Accessibility Survey

City of Downey Dolan Avenue - 6th Street to 5th Street

Date of Inspection
7/18/2017

Prepared By
Disability Access Consultants
(800) 743-7067

Change In Level North Of Cheyenne Street @ 33.915181755027, -118.148973584175

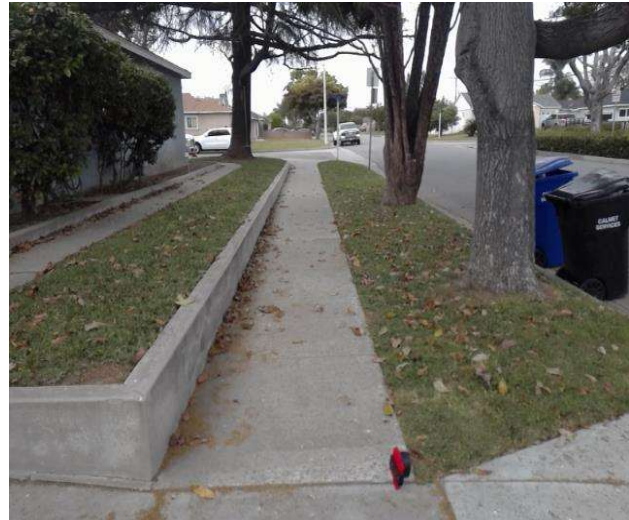
There is a change in elevation greater than recommended value.

On-Site Finding 0.62 inches

Ensure that the change in elevation is within the recommended value.

Recommendation Up to 0.25 inches

Change in Level South of Iowa Street @ 33.936836717311, -118.133093565702

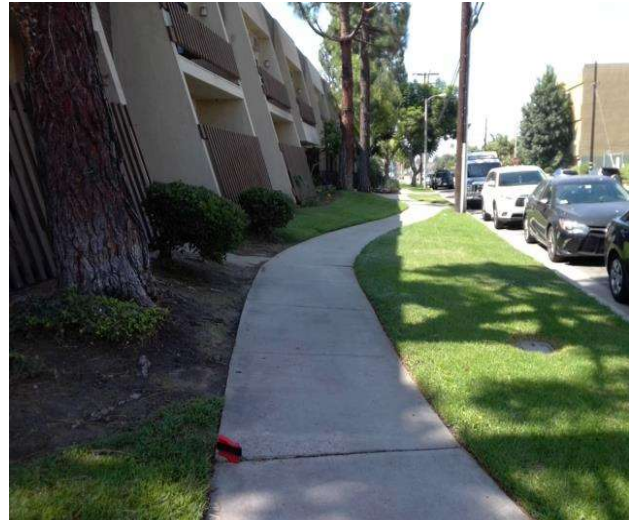
There is a change in elevation greater than recommended value.

On-Site Finding 0.75 inches

Ensure that the change in elevation is within the recommended value.

Change in Level North of Davis Street @ 33.936331571766, -118.133718520403

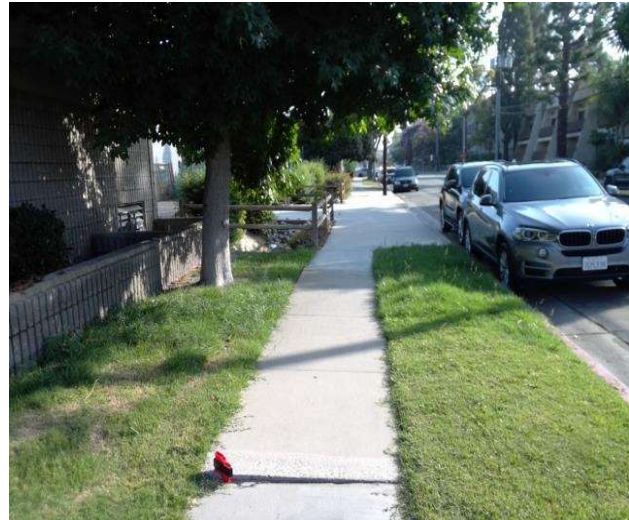
There is a change in elevation greater than recommended value.

On-Site Finding 1.12 inches

Ensure that the change in elevation is within the recommended value.

Change in Level North of Davis Street @ 33.936792211216, -118.133368492126

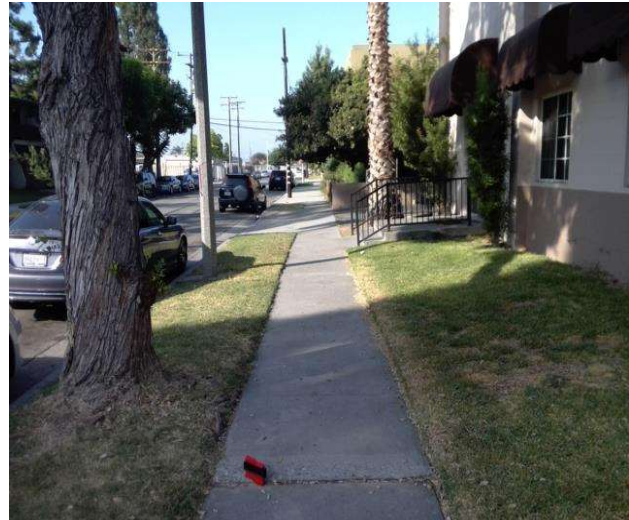
There is a change in elevation greater than recommended value.

On-Site Finding 0.50 inches

Ensure that the change in elevation is within the recommended value.

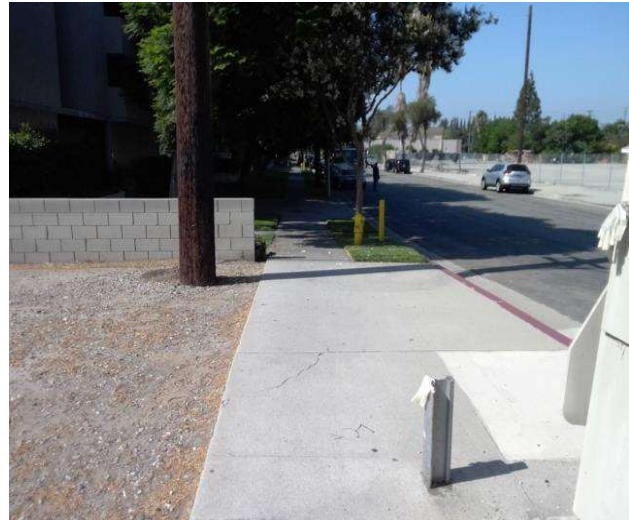
Sidewalk width at the obstruction is not compliant.

On-Site Finding 46.50 inches

Sidewalk width at the obstruction shall have the recommended value.

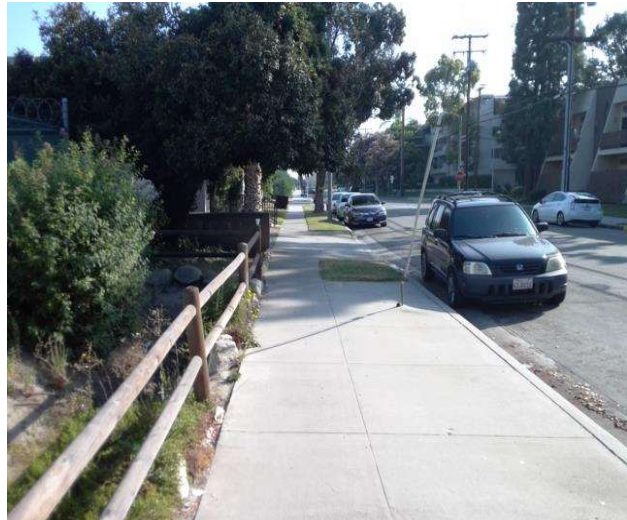
Sidewalk cross slope is not compliant.

On-Site Finding 4.20 percent for 36.00 feet

Repave the sidewalk surface with the recommended cross slope.
